STATE OF MAINE
DEPARTMENT OF TRANSPORTATION
16 STATE HOUSE STATION
AUGUSTA, MAINE 04333-0016

January 19, 2023
Subject: Acadia Gateway
State WIN: 017163.03
Location: **Trenton**
Amendment No. 5

UTILITY PLAN - EAST

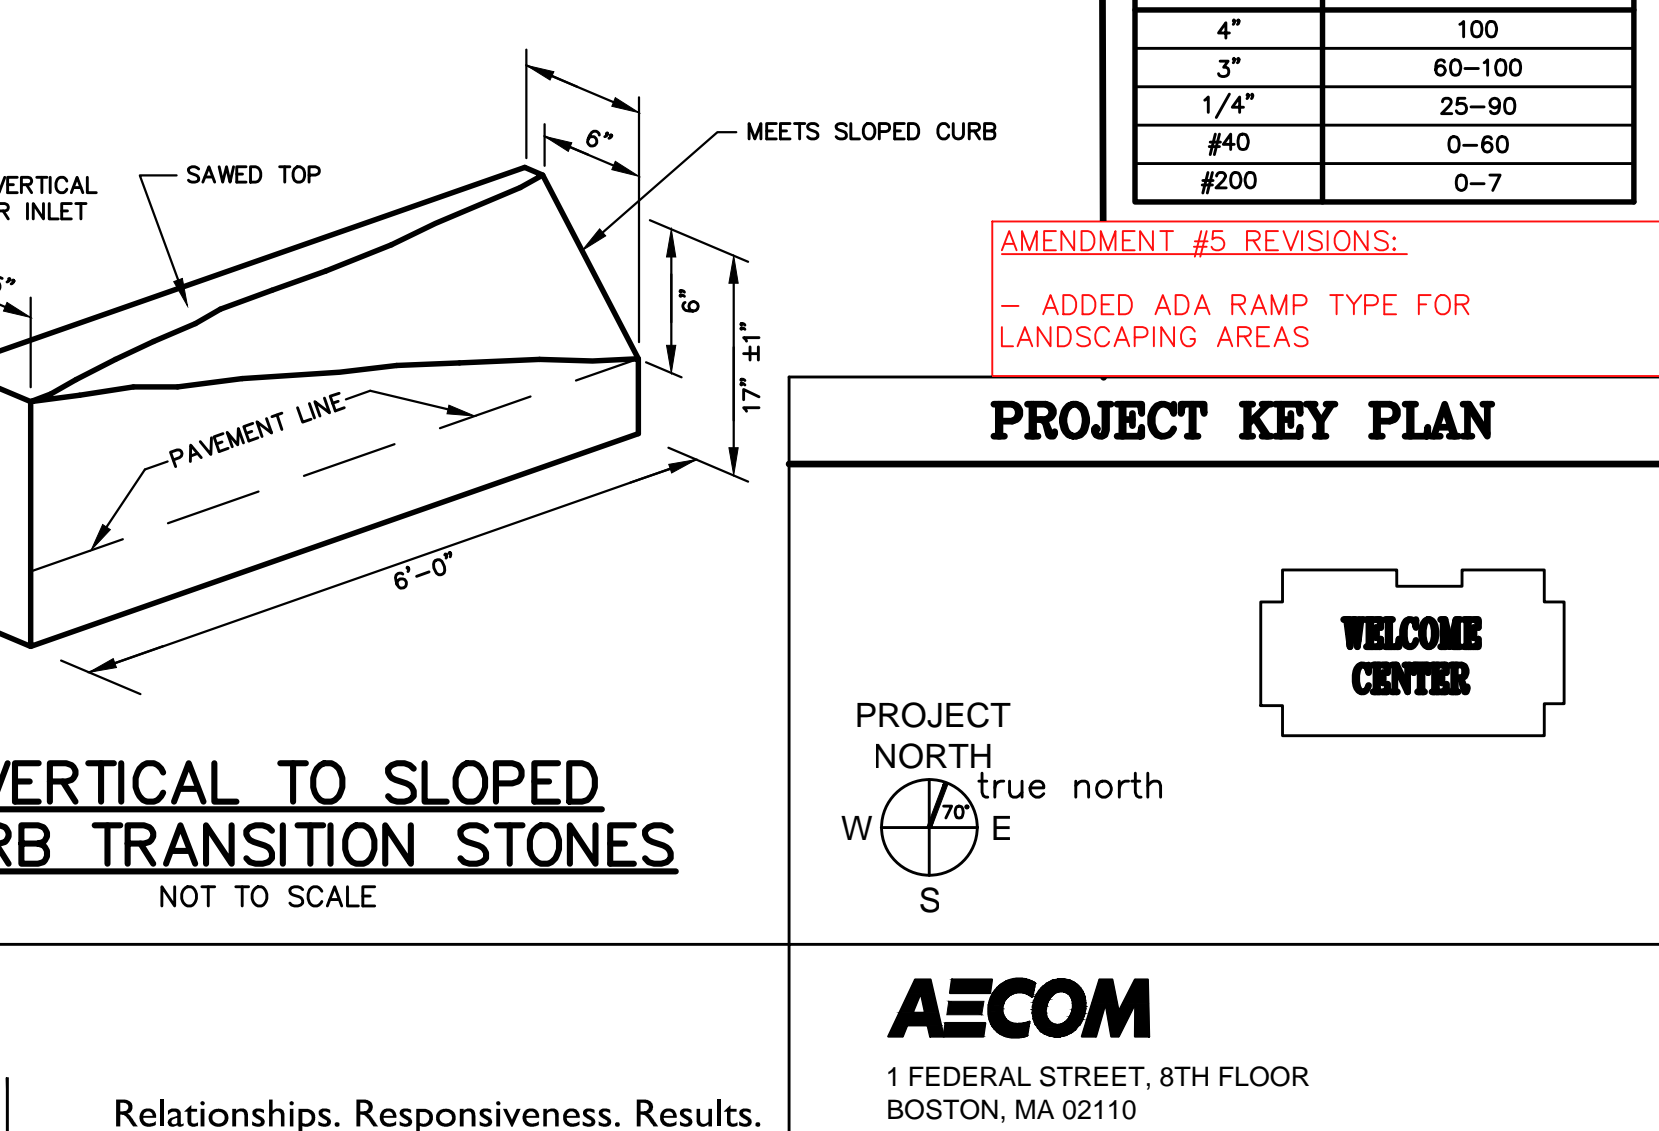
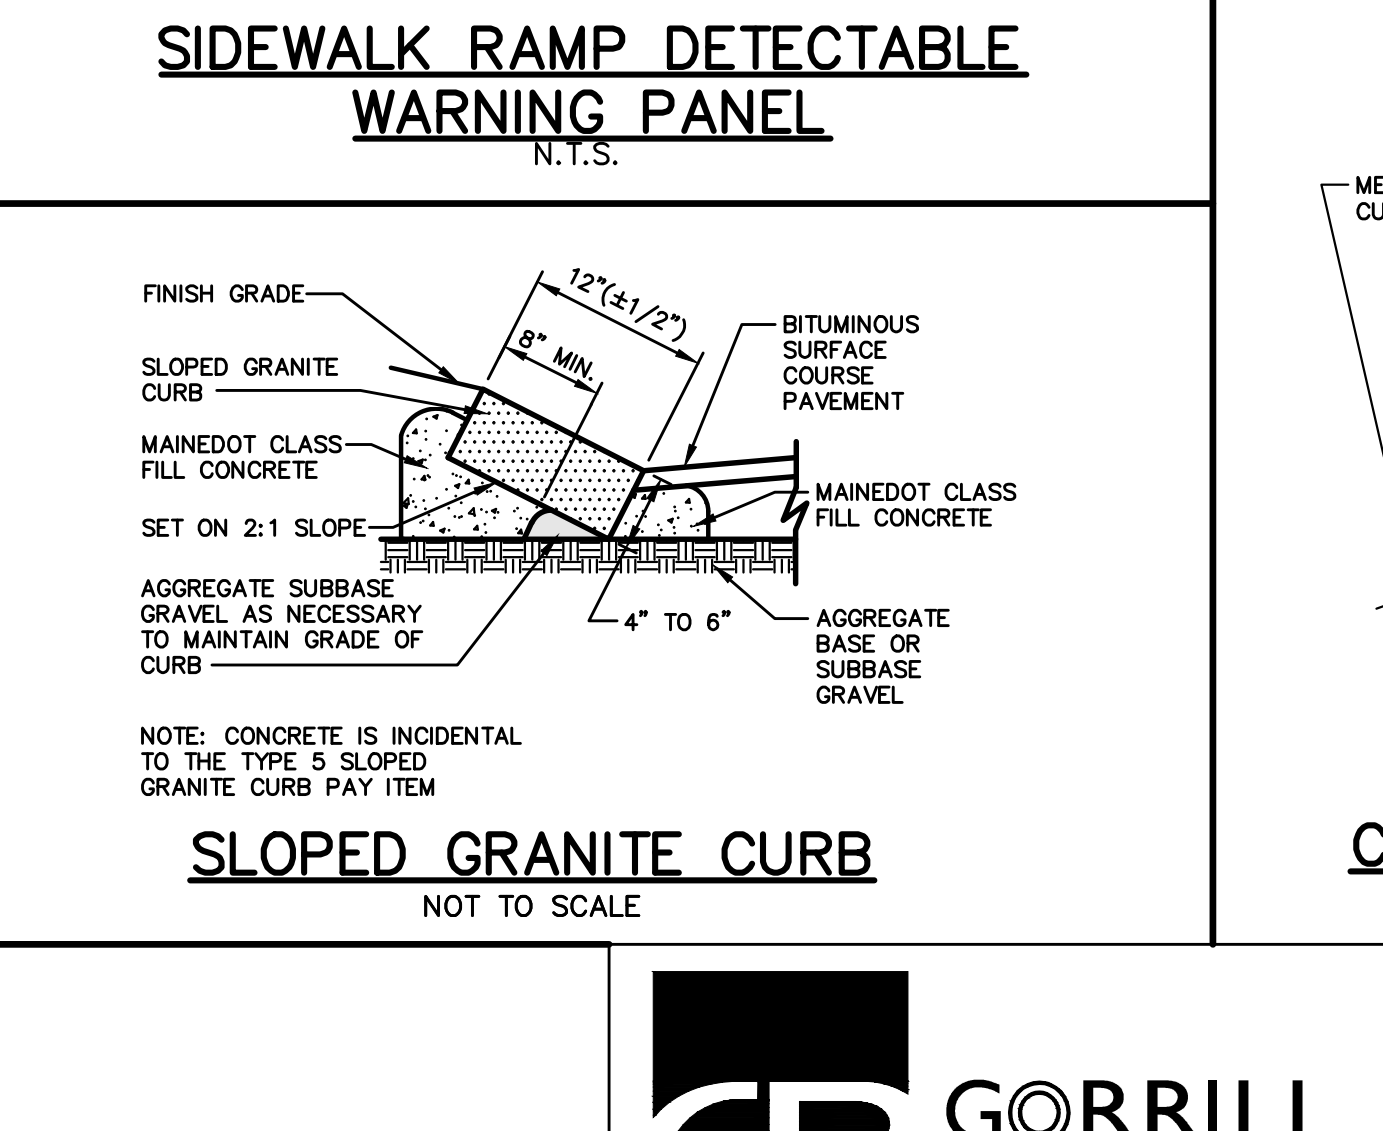
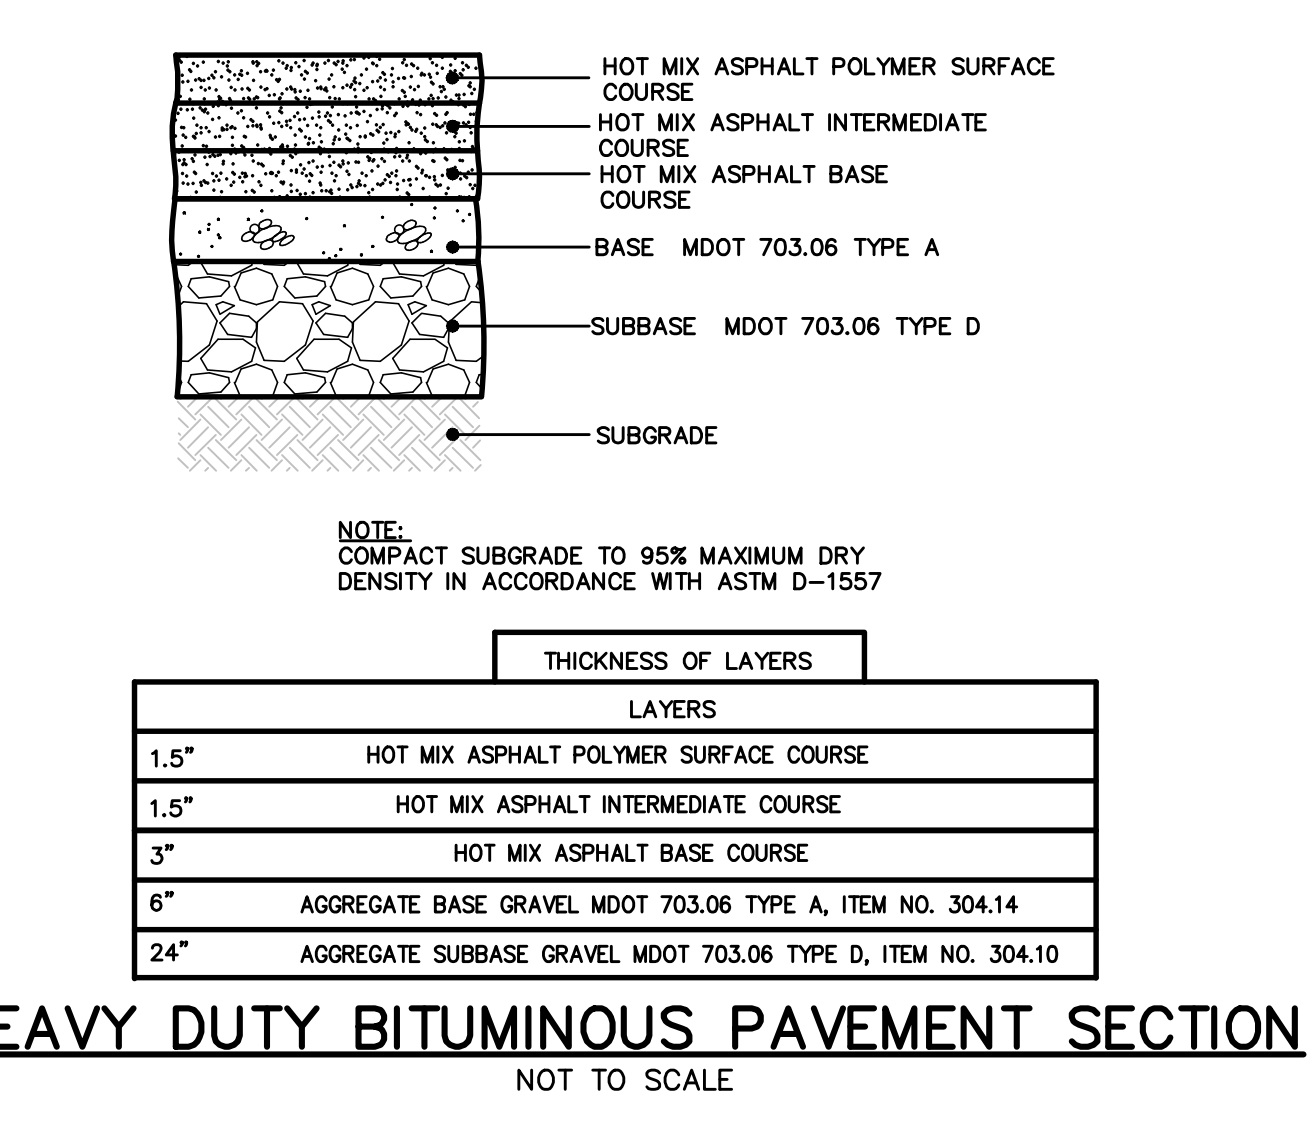
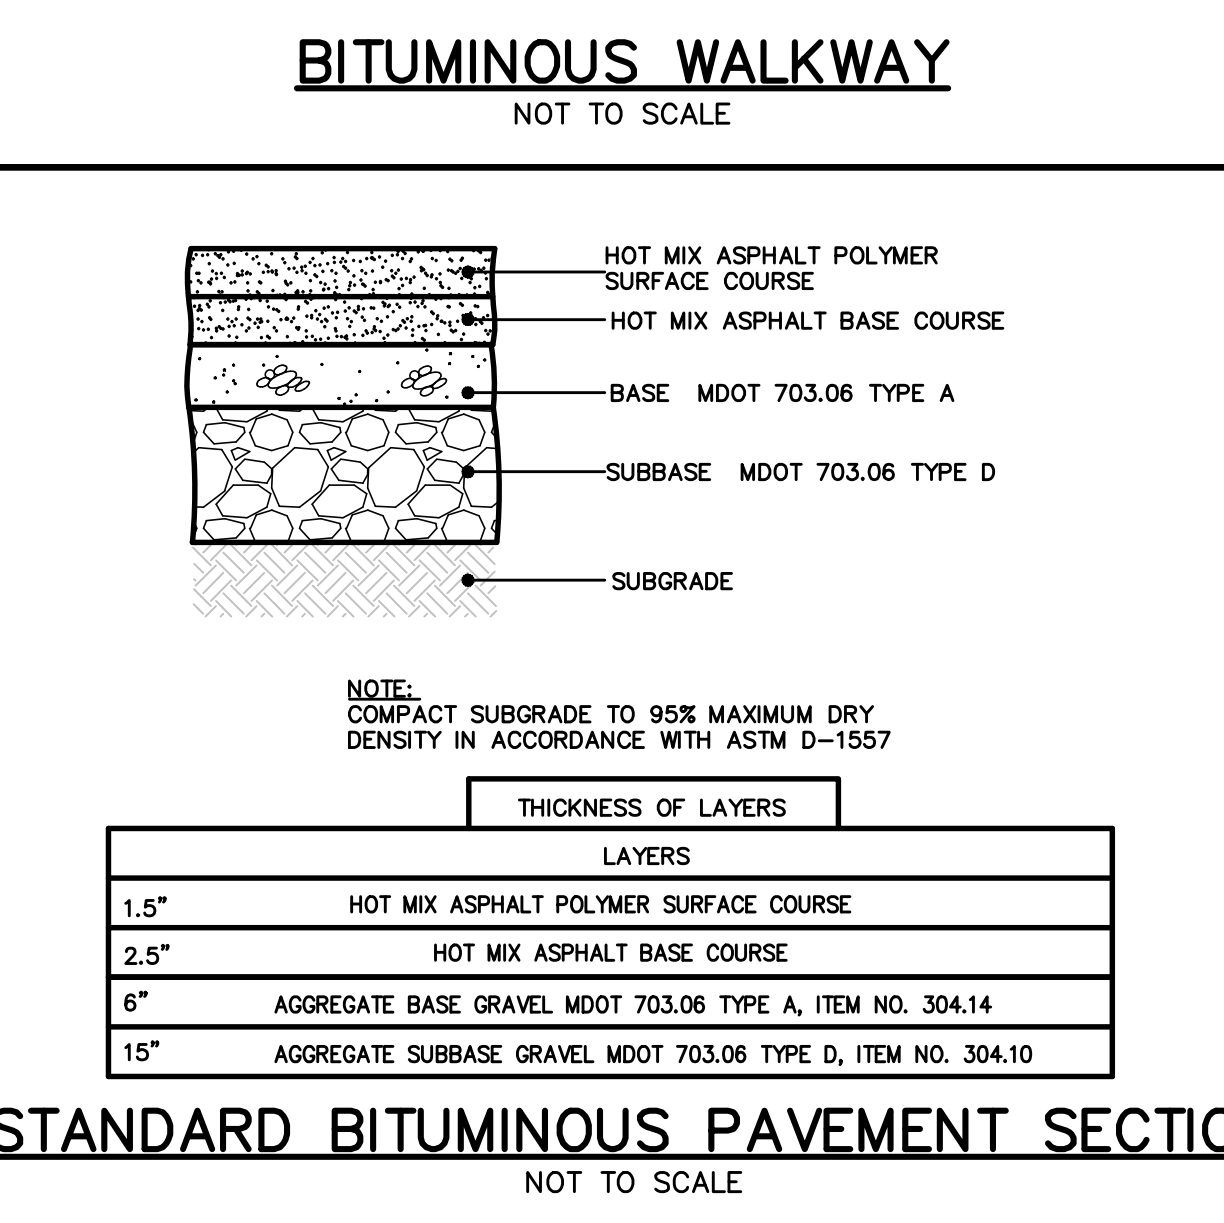
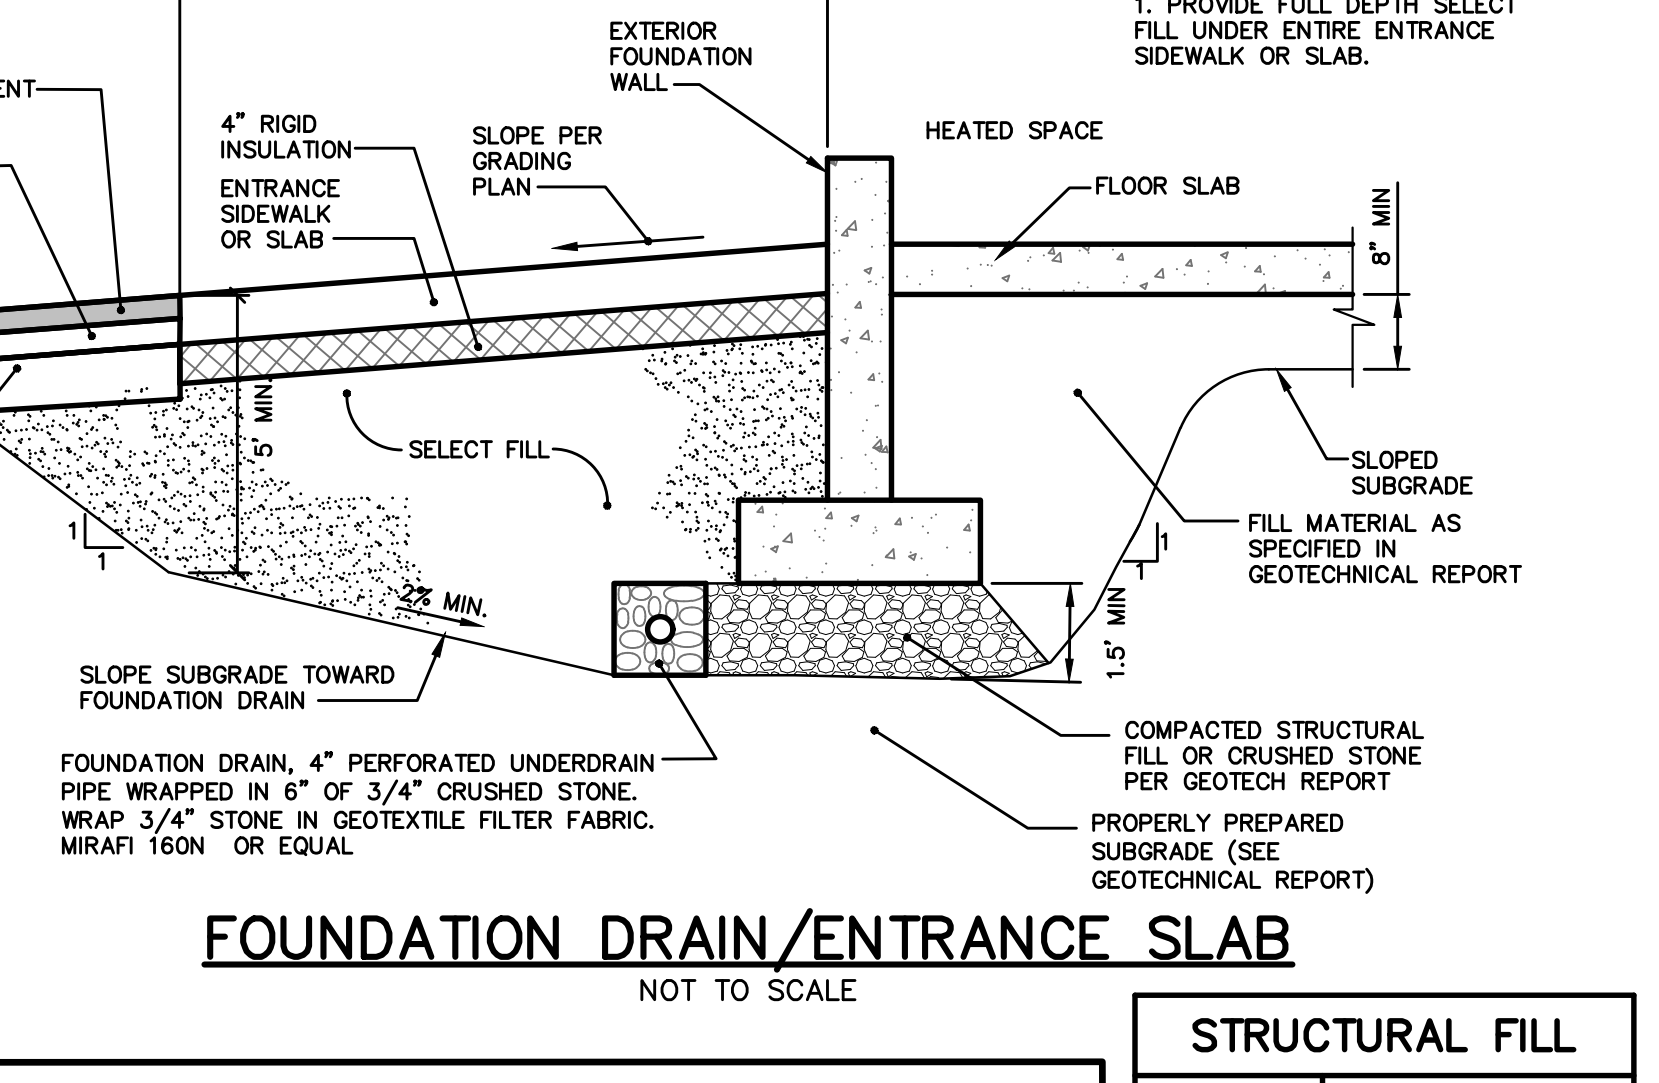
Question: It appears that there is a Ramp with Detectable Warning Pavers near the NE corner of the Bus Shelter, but it is not identified similar to the other Ramps on the plan sheet. Please clarify.

Response: The ramp in this location has been removed. The curb bump out will remain, without a ramp. C202 has been updated in Amendment #5.
